Well Name: SJU TR-B	Well Location: T25S / R37E / SEC 11 / NENW / 32.1510917 / -103.134663	County or Parish/State: LEA / NM
Well Number: 11	Type of Well: OIL WELL	Allottee or Tribe Name:
Lease Number: NMLC032511F	Unit or CA Name: SOUTH JUSTIS UNIT	Unit or CA Number: NMNM87877X
US Well Number: 3002520275	Operator: LEGACY RESERVES OPERATING LP

P&A Procedure for the South Justis Unit #B11

BLM Revised P&A Procedure

**Permanent Abandonment of Federal Wells
Conditions of Approval**

PROPOSED P&A'd WELLBORE

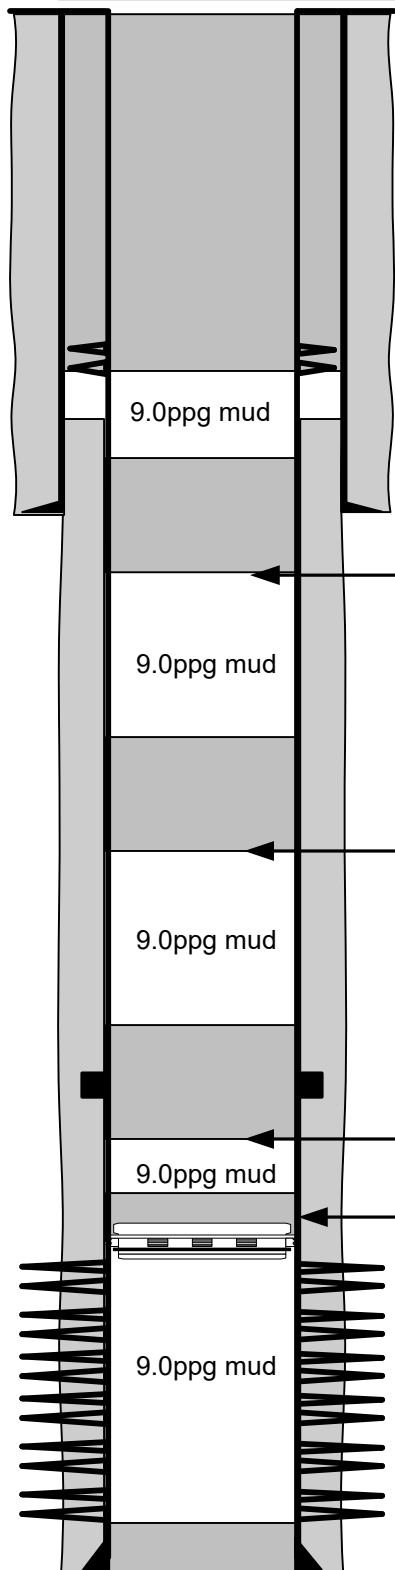
Must run CBL and file on NMOCD permitting app

6. RIH w/ dump bailer & spot **35 ft** Class C cement on top of CIBP w/ TOC @ 5065'. POOH w/ dump bailer & RD e-line. **WOC and TAG Pressure Test**
7. Spot balanced 33sxs Class C cement plug at 4871'-4721' to cover DV Tool. **WOC and TAG(DV Tool, T/ Glorieta)**

8. Spot balanced 30sxs Class C cement plug at 3360-3230'.
9. Spot CI C cmt at 2400 ft to 2200ft. **WOC and TAG(T/Yates)**
10. Spot balanced 25sxs Class C cement plug at 1192-1082'.WOC and TAG (Surf. Shoe, T/Salt)
